Index 521-001 Concrete Barrier

ORIGINATION

Date: July 31, 2019

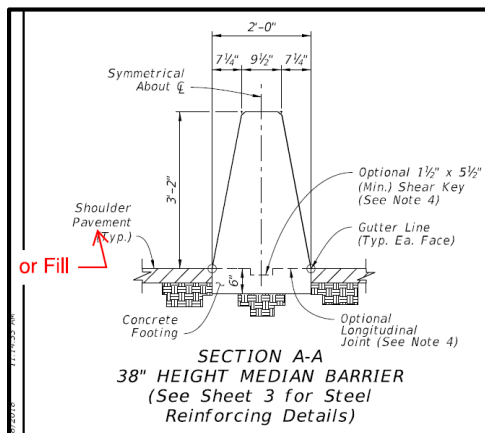
- (1) Regarding the inclusion of the note "...or Fill" (as shown below) in the median barrier wall section, does this mean asphalt is no longer needed on both sides of the median barrier wall for overturning? Was this change to allow the use of median barrier wall at toll sites with the 6" stem? Asphalt is not required.
- (2) Our understanding is that the "...or Fill" notation was added to include the condition when barrier wall is utilized outside of paved limits, but this should be clarified with a note to clearly specify when fill can be utilized.
- (3) If fill is allowed, shouldn't it be specified that sod is required to avoid any issues with erosion?

Agreed. Proposed fill callout will be removed.

The fill option was proposed to provide flexibility to cover median conditions encountered on several recent projects. That said, this fill option will not be added to the Standards until additional explanation for grading requirements can be provided along with it.
